<b>ITEM: 6.10</b>	<b>REPORT SUMMARY MINOR VARIANCE APPLICATION FILE NUMBER A177/24</b>
-------------------	--

**MINOR VARIANCE APPLICATION  
FILE NUMBER A177/24**

<b>CITY WARD #:</b>	5
<b>APPLICANT:</b>	Chabad Lubavitch of Southern Ontario
<b>AGENT:</b>	Darrin Cohen, Weston Consulting
<b>PROPERTY:</b>	8001 Bathurst Street, Vaughan
<b>ZONING DESIGNATION:</b>	See below.
<b>VAUGHAN OFFICIAL PLAN (2010) DESIGNATION:</b>	Vaughan Official Plan 2010 ('VOP 2010'): "Mid-Rise Residential" (OPA 89)
<b>RELATED DEVELOPMENT APPLICATIONS:</b>	DA.24.004
<b>PURPOSE OF APPLICATION:</b>	Relief from the Zoning By-law is being requested to permit a five-storey mixed use addition to the existing synagogue and to facilitate related Site Plan Application DA.24.004.

SHEET NUMBER  
**A-201**

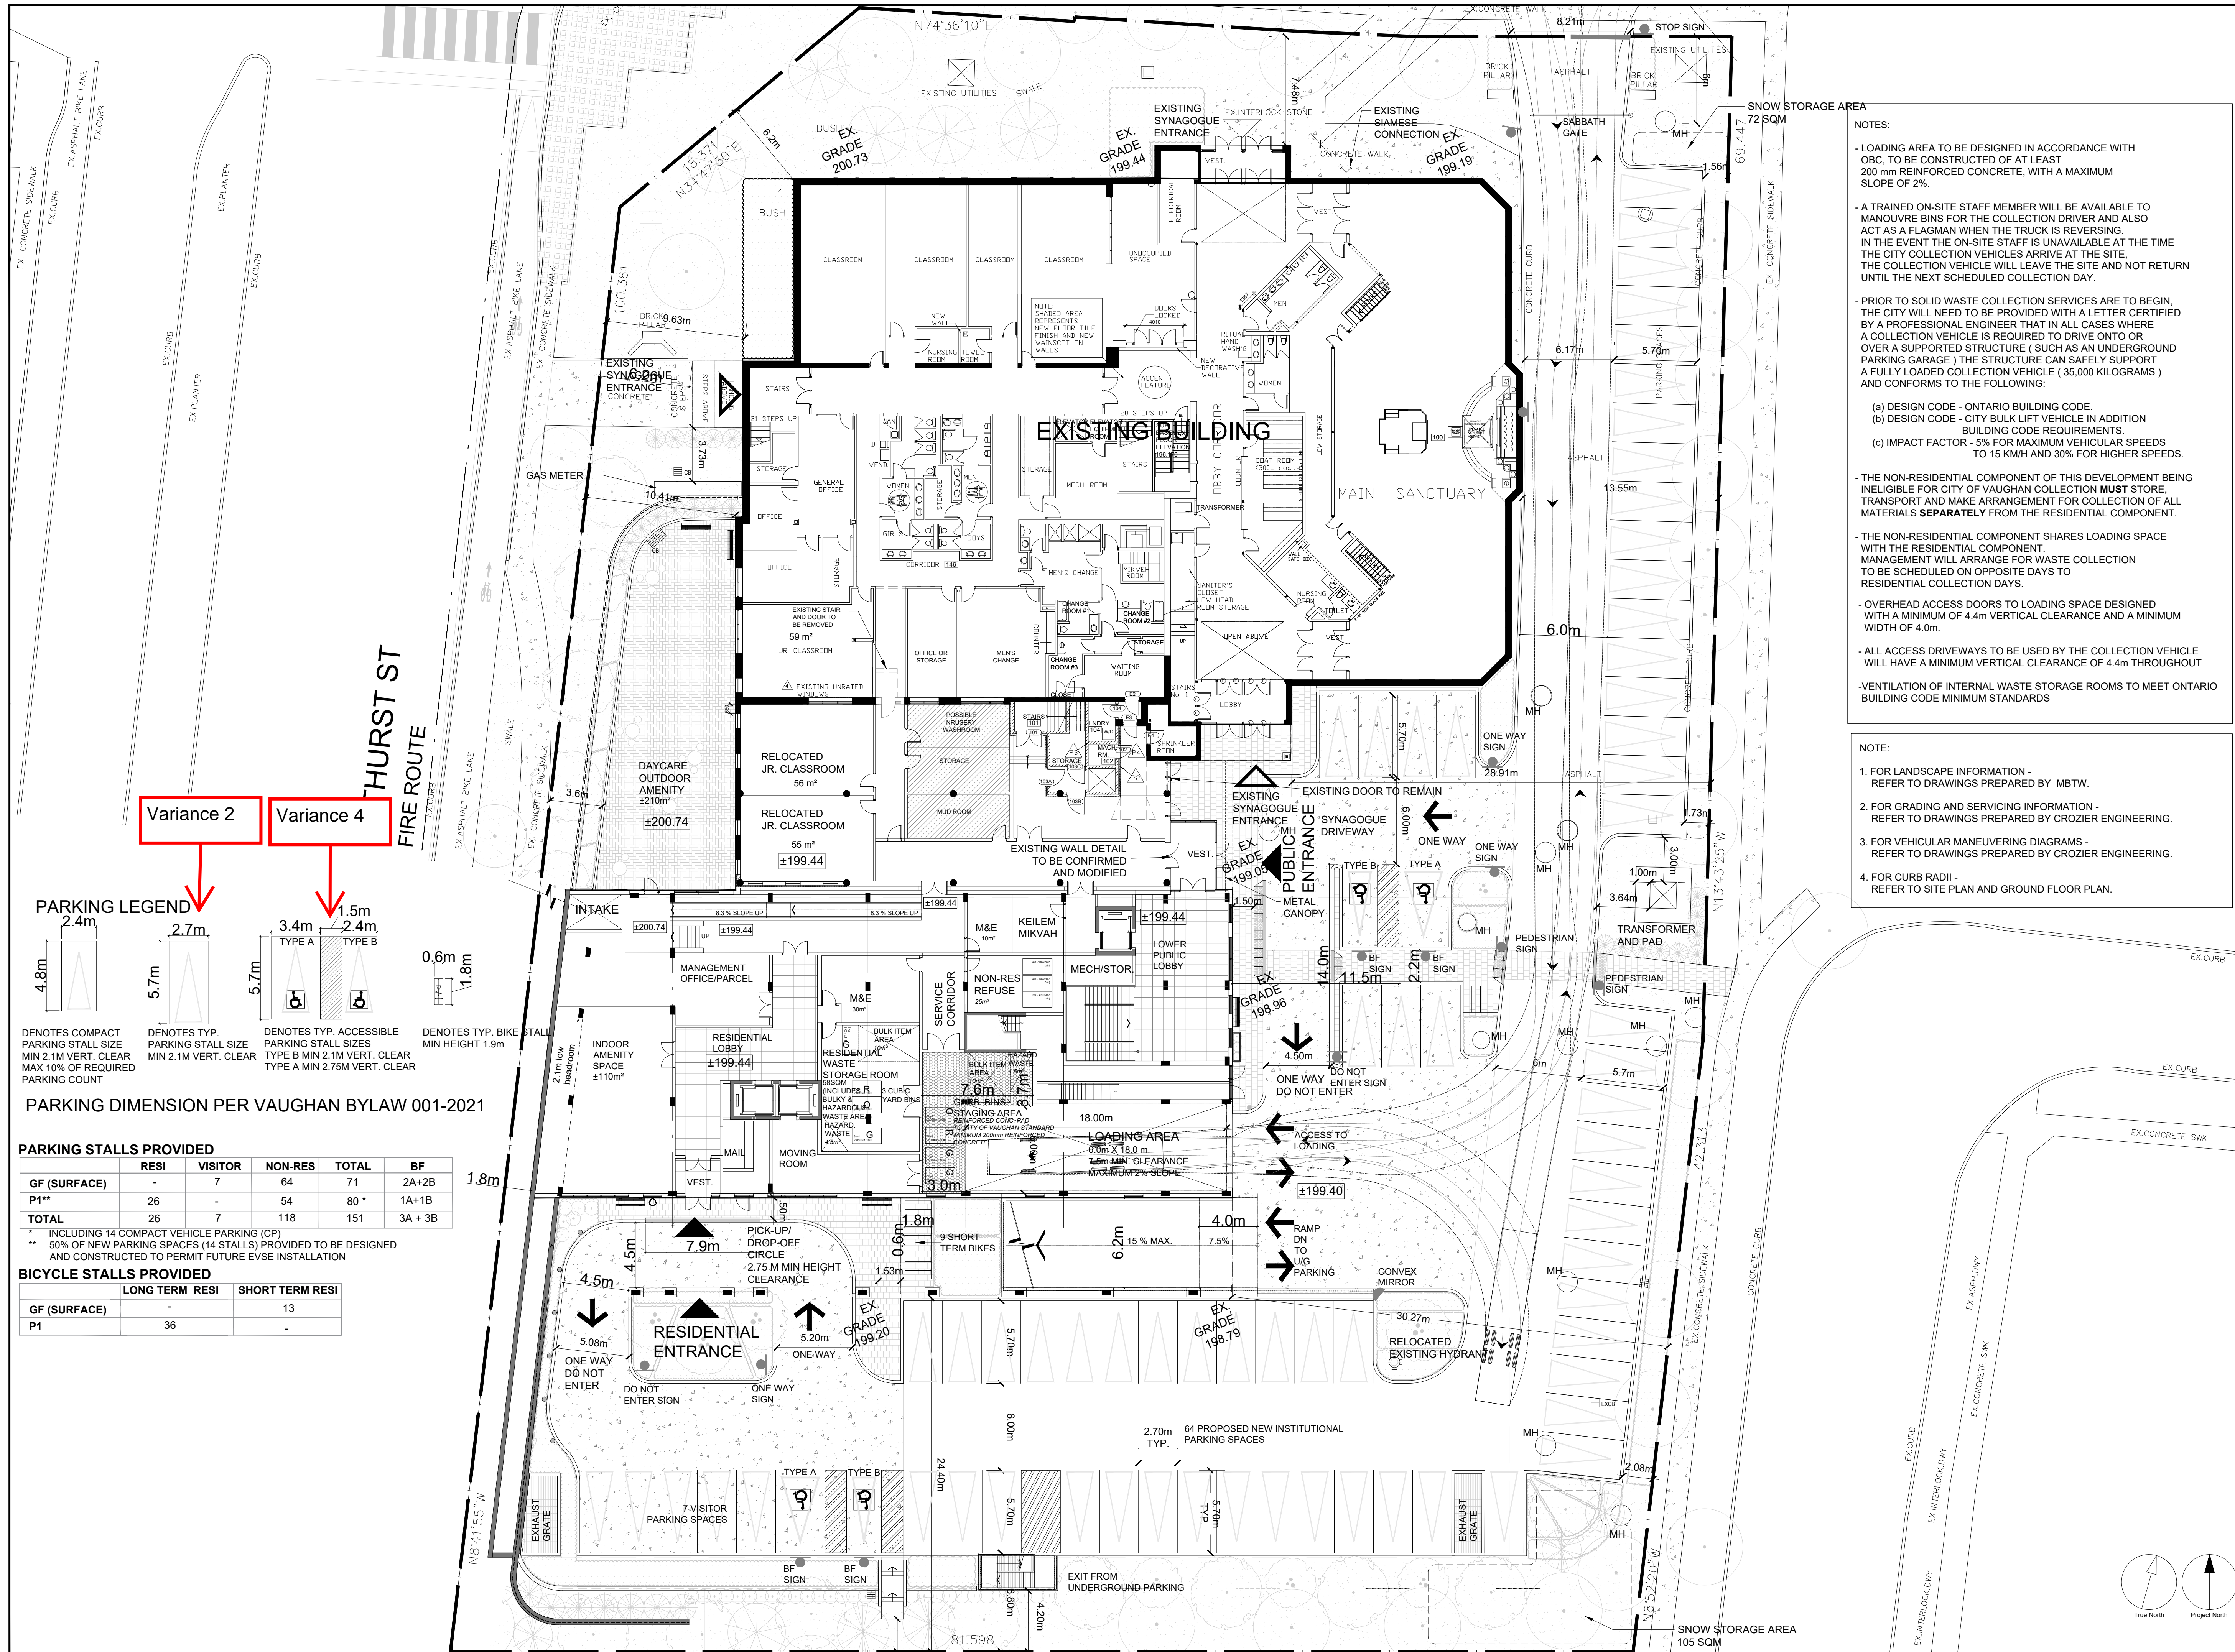
The Development and Parks Planning Department has no objection to Variances 2 and 4 to reduce the minimum parking space lengths from 6.0 m to 5.7 m for standard parking spaces and barrier-free parking spaces. The proposed length of 5.7 m is compliant with standards in Zoning By-law 001-2021, but is identified as deficient when reviewed under Zoning By-law 1-88. Development Engineering staff have reviewed the reduced parking space lengths and do not have any concerns with accessibility and vehicular maneuverability.

The Development and Parks Planning Department has no objection to Variance 3 to permit a total of 14 compact parking spaces, measuring 2.7 m by 4.8 m in dimensions, to be located in the single-storey underground parking structure proposed on the Subject Lands. Policy 4.3.2.7 of the Official Plan speaks to the development of parking lots and parking structures, and places emphasis on the provision of a range of parking space types, including parking for smaller fuel efficient vehicles. Zoning By-law 001-2021 permits a maximum of 10% of the total required parking spaces to be compact parking spaces with a minimum dimension of 2.4 m by 4.8 m. The proposed development requires a total of 143 parking spaces, and the 14 proposed compact parking spaces is compliant under Zoning By-law 001-2021. Development Engineering staff have reviewed the dimensions of the proposed compact parking spaces and do not have any concerns with accessibility and vehicular maneuverability.

SHEET TITLE  
**WEST & SOUTH ELEVATIONS**

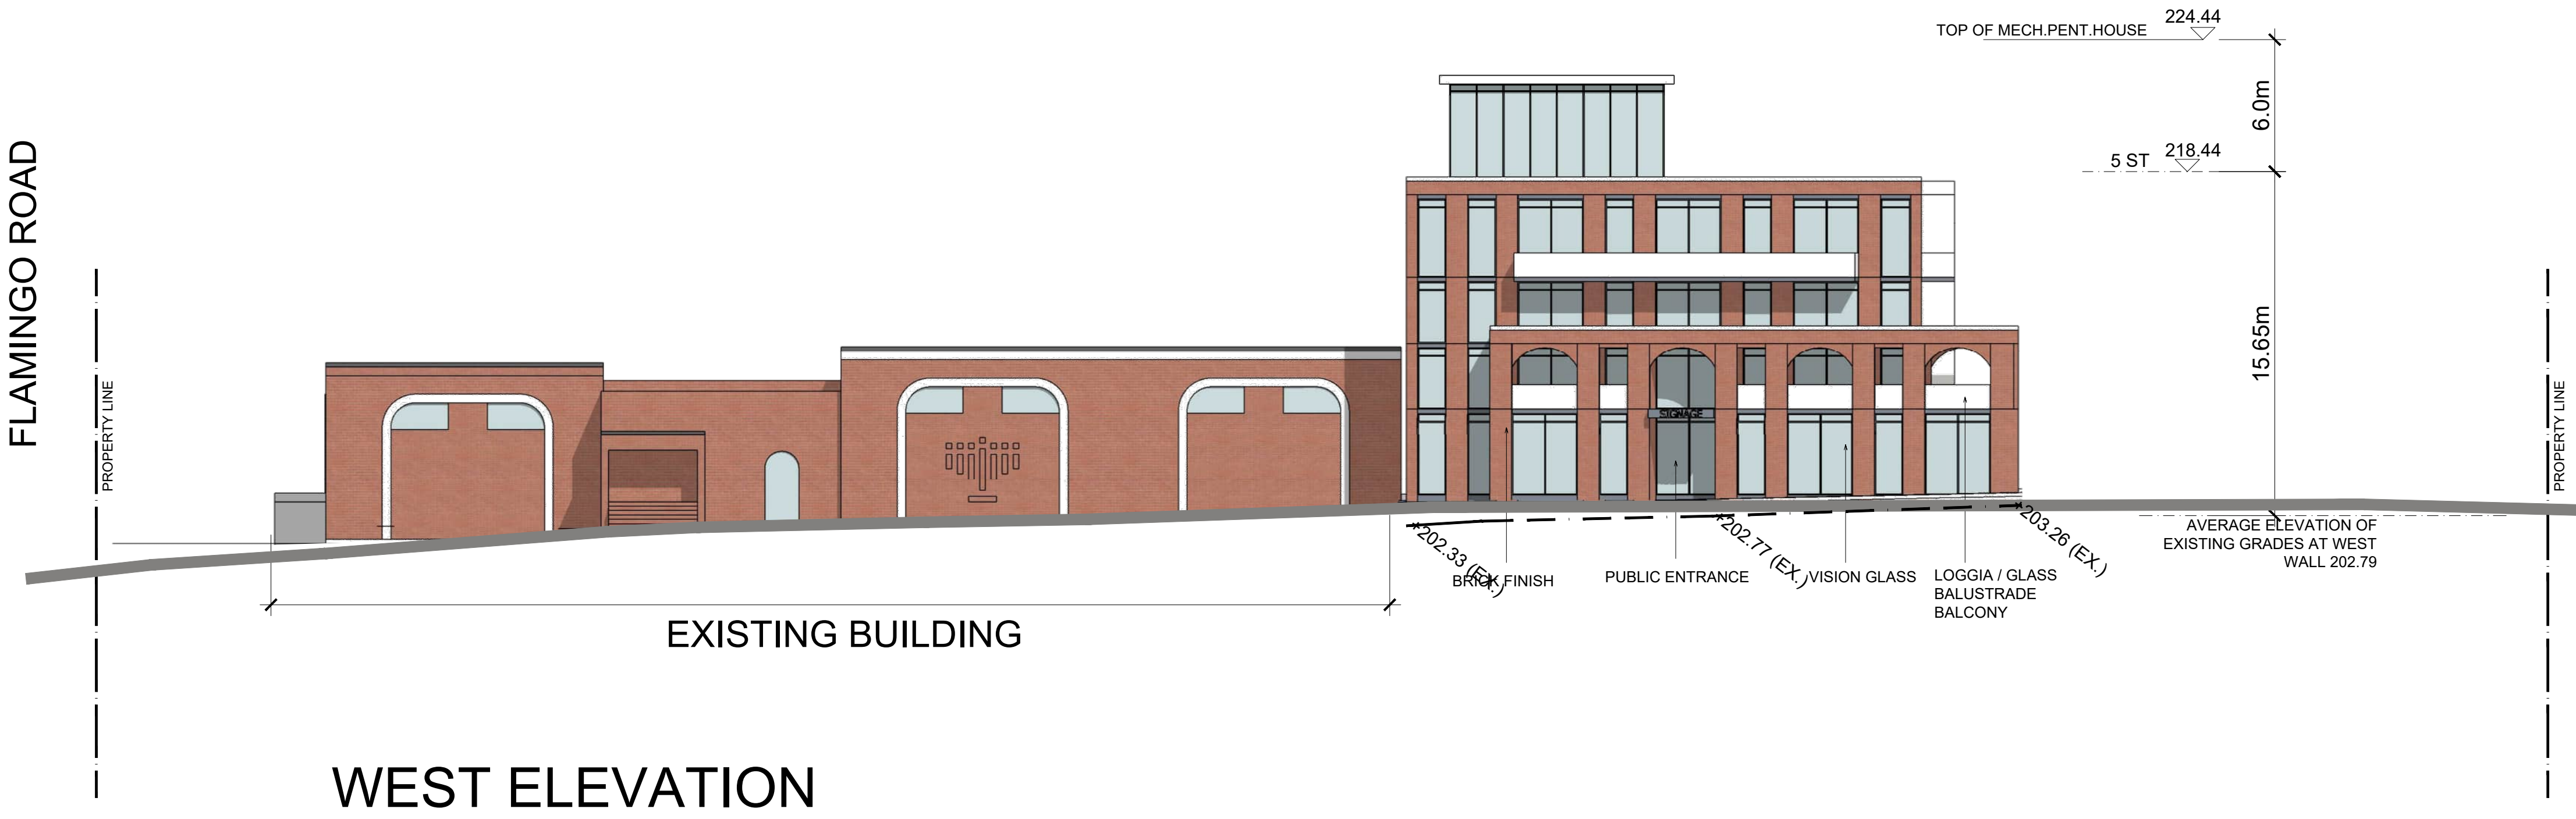
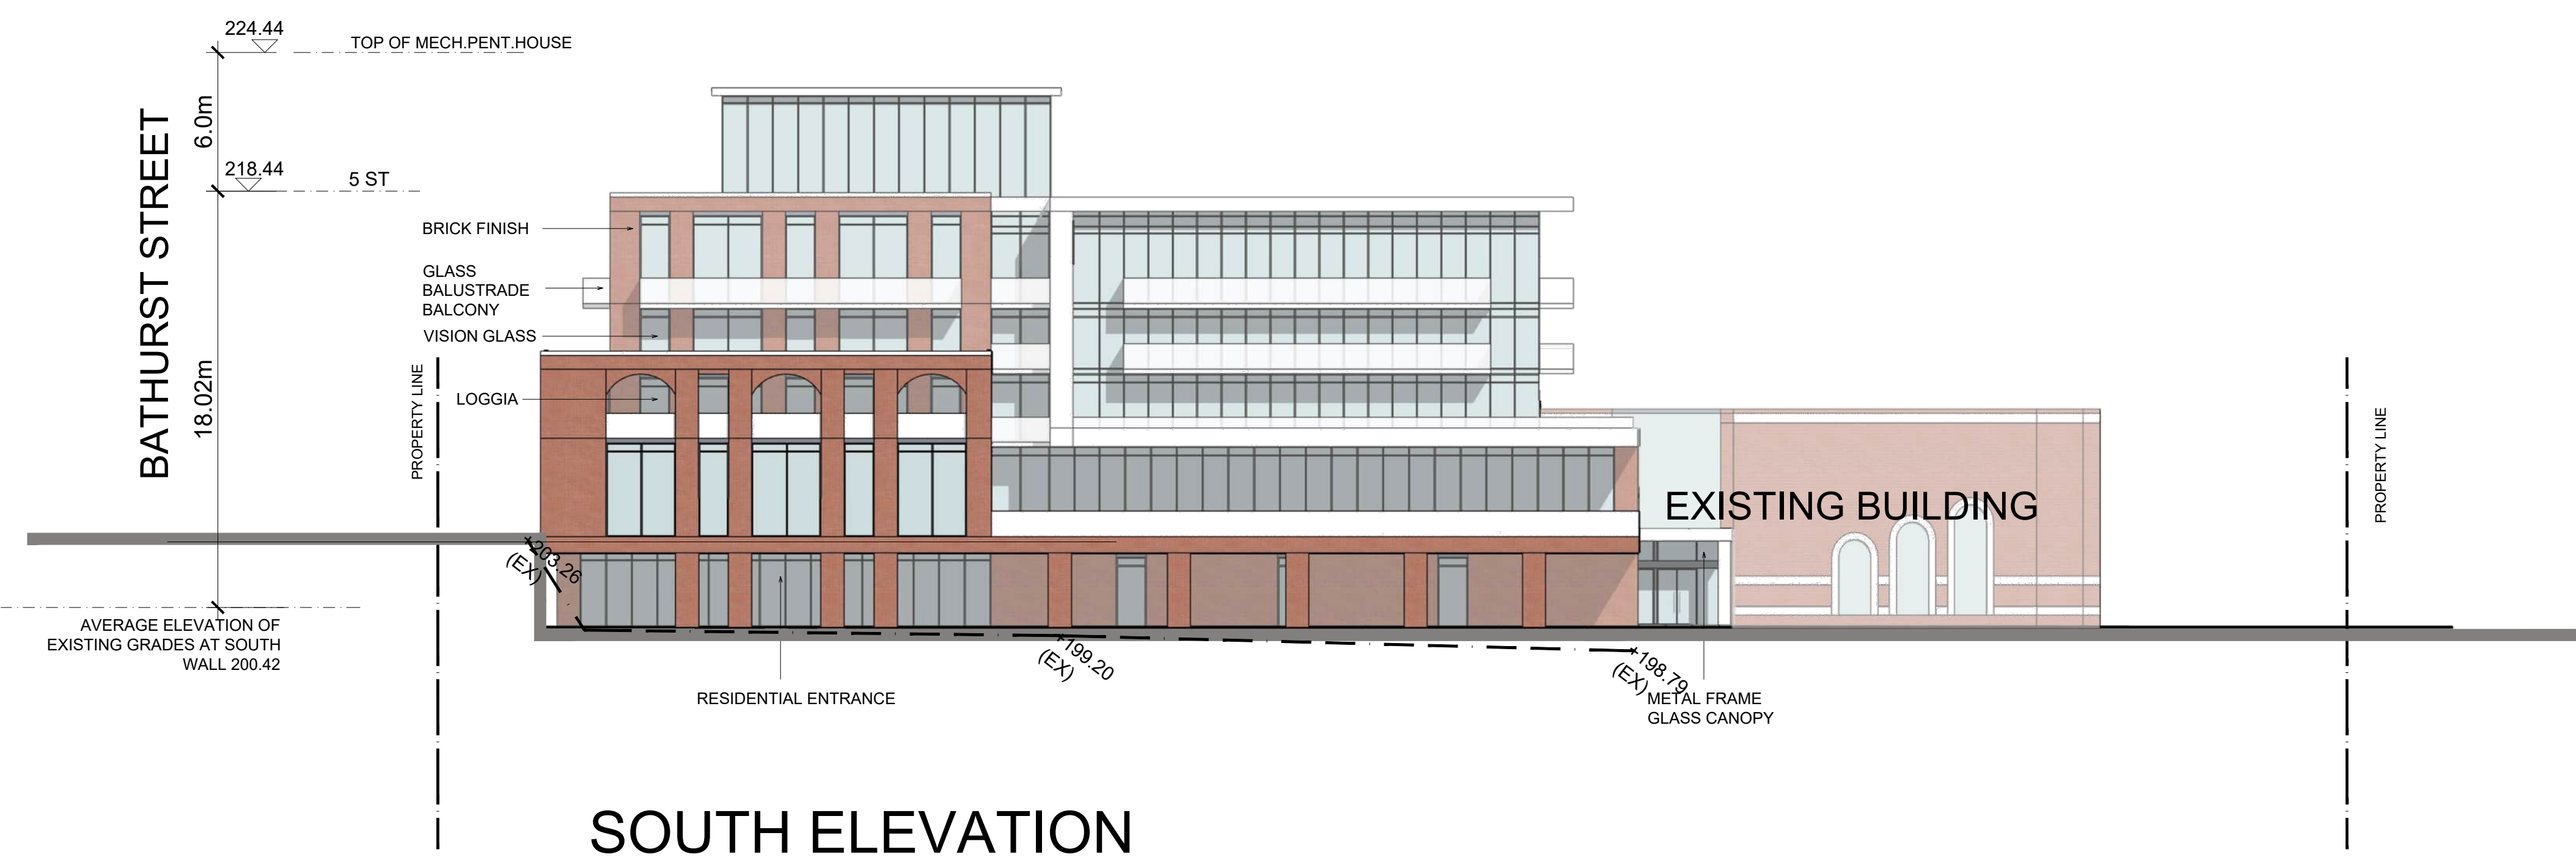
The Development and Parks Planning Department has no objection to Variance 1 to increase the maximum permitted height of the building addition from 18 m to 18.7 m and to increase the maximum permitted height of the mechanical penthouse from 5.3 m to 6.0 m. The 0.7 m increase in the height of the building addition has been proposed to facilitate additional headroom to accommodate a variety of technical features for the second and fifth storeys. The 0.7 m increase in the height of the mechanical penthouse is requested to accommodate oversized equipment proposed to be located in the mechanical penthouse.
